# Review of NIOSH Response to SC&A Comments on ORAUT-RPRT-0090

To the Advisory Board on Radiation and  
Worker Health ORNL (X-10) Work Group  
June 30, 2021

# Observation 6: Comparison of radioiodine production

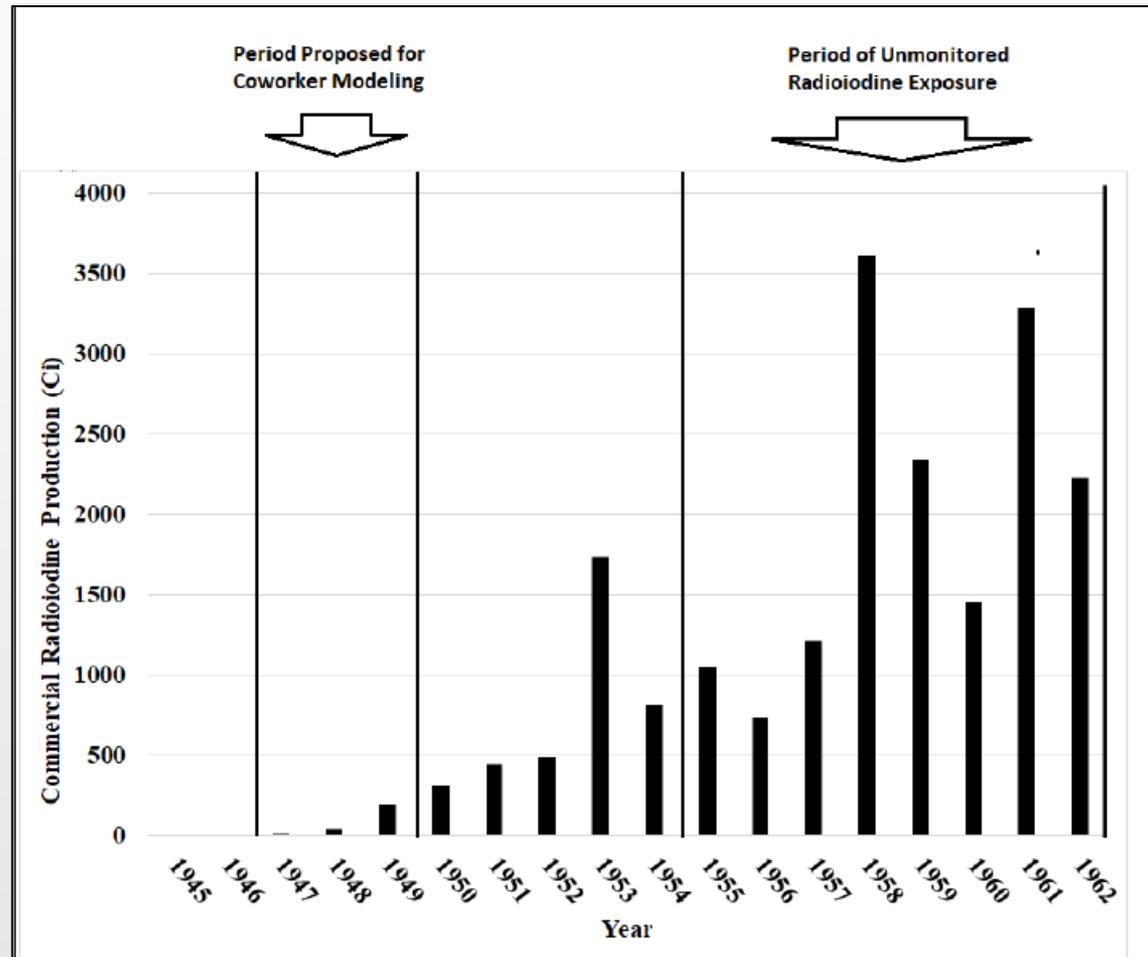
- ◆ Extrapolating exposure estimates from one period to another requires careful comparison of operations.
  - Implementation criteria (IG-006) require comparison of operations even when combining multiple years for co-exposure analysis
  - Production output for commercial operations 1956–1962 (limited monitoring data) was significantly higher than commercial output 1947–1949 (proposed co-exposure period)
- ◆ Contention that workers (1956–1962) were not exposed to levels that would have triggered monitoring cannot be evaluated.
  - Limited monitoring data 1956–1962
  - Reason for applying co-exposure estimates for 1947–1949

- ◆ NIOSH agrees that RaLa radioiodine production and commercial radioiodine production are different.
- ◆ Both activities were done in the same areas with the same radiological controls.
- ◆ Unlikely workers (1955–1962) were exposed to levels that would have triggered the monitoring program.
